ALAMEDA COUNTY  
HEALTH CARE SERVICES

August 4, 2006

Subject: Fuel Leak Case No. RO0000396, Former Service Station, 2547 East 27<sup>th</sup> Street, Oakland, CA

# Attachment 1 - Revised Soil Excavation Map

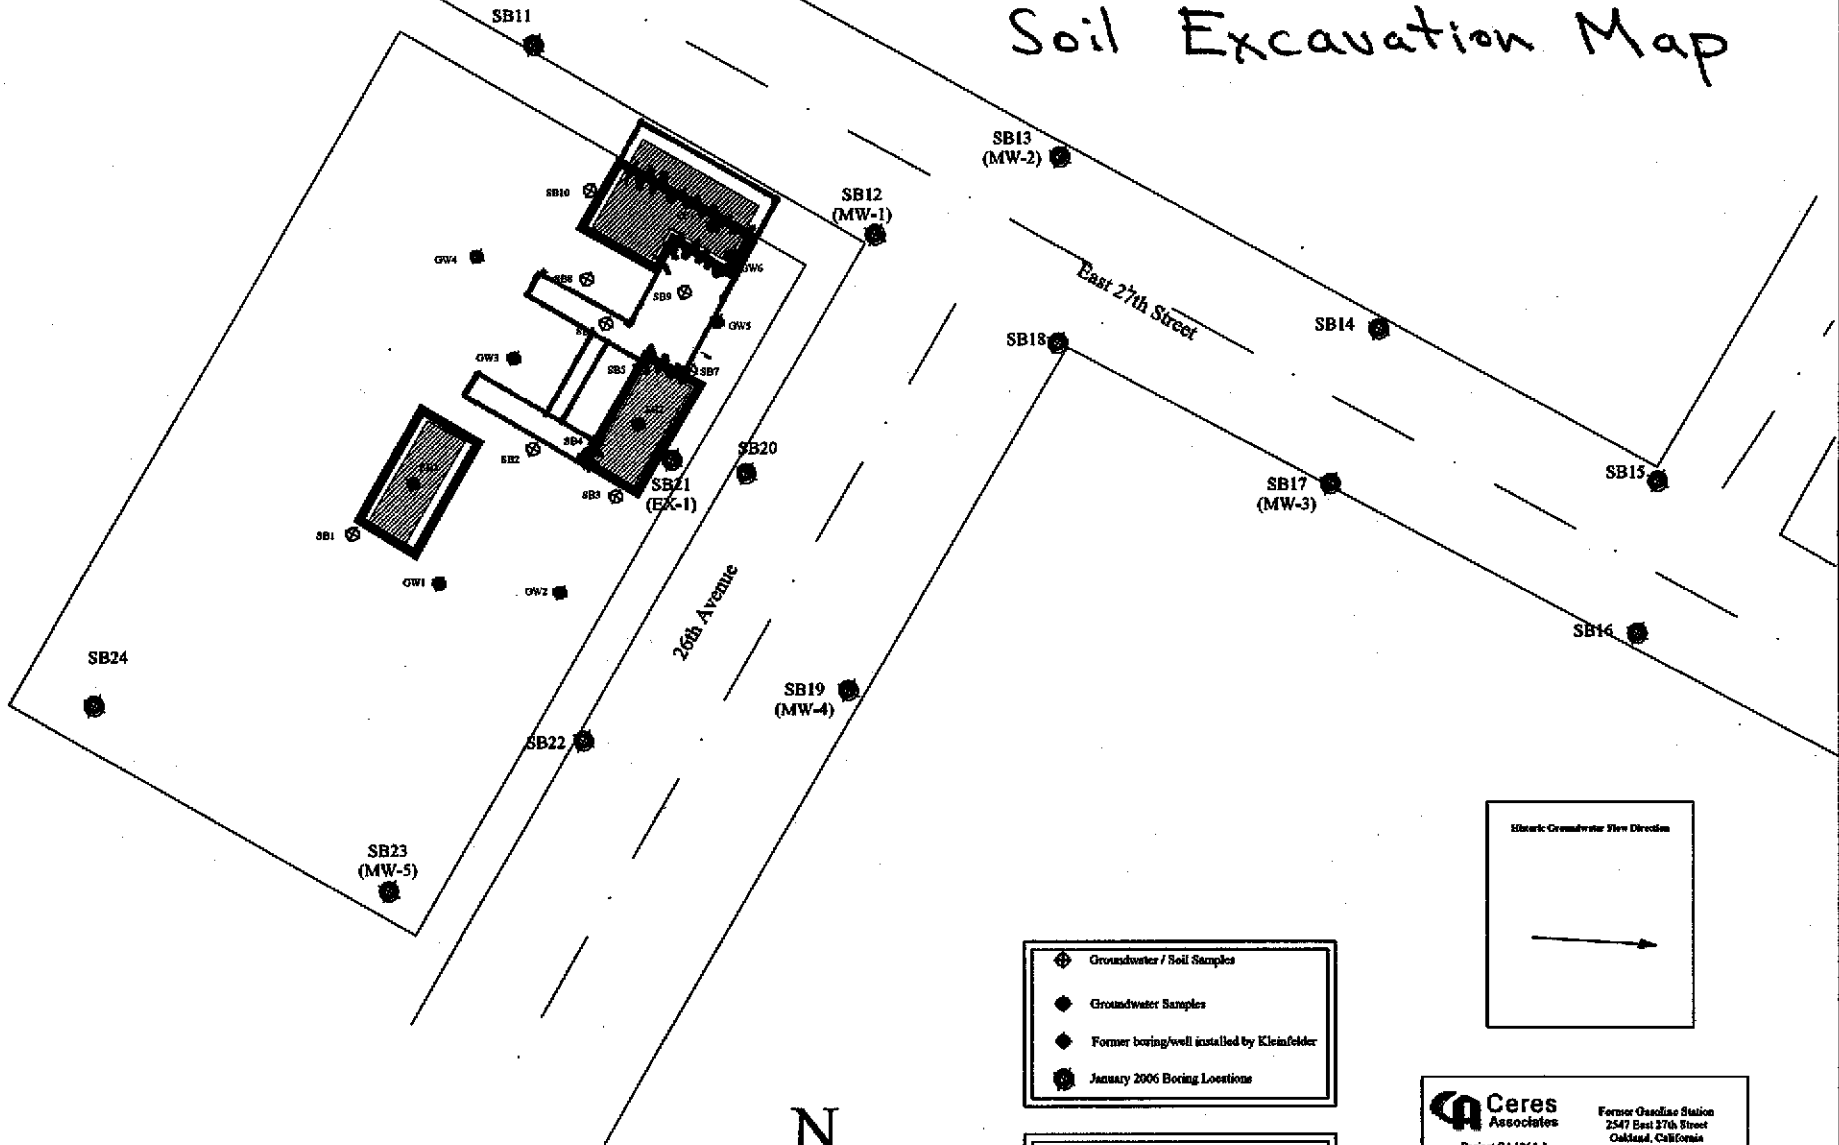
2. **Extent of Proposed Excavation.** The extent of presumed excavation shown on the "Soil Excavation Map," needs to be expanded to address the areas of known contamination and limitations of the scope of the 1994 tank removal. The purpose of the excavations is to remove residual contamination that poses a long-term potential for exposure and will be a long-term source of groundwater contamination. A revised Soil Excavation Map is included as Attachment 1. The revised extent of excavation on Attachment 1 includes an expanded area to the north beneath the sidewalk along East 27<sup>th</sup> Street, where contaminated soils were backfilled and the area around boring SB9, where a concentration of 750,000 micrograms per liter ( $\mu\text{g/L}$ ) of TPHd was detected in groundwater. A concentration of 750,000  $\mu\text{g/L}$  of TPHd exceeds the solubility of TPHd in water and likely represents the presence of free product in the area sampling location SB9. Only two shallow soil samples were collected from the area of the former dispensers, which is not sufficient to evaluate whether the former dispensers and product piping were sources of residual soil and groundwater contamination. Therefore, trenches have been added in the area of former dispensers and likely areas of product piping. If soil contamination is observed along the trenches, the excavation is to be expanded beyond the trenches to remove the observed contamination. Please present the results in the Soil Excavation and Soil Boring Report requested below.
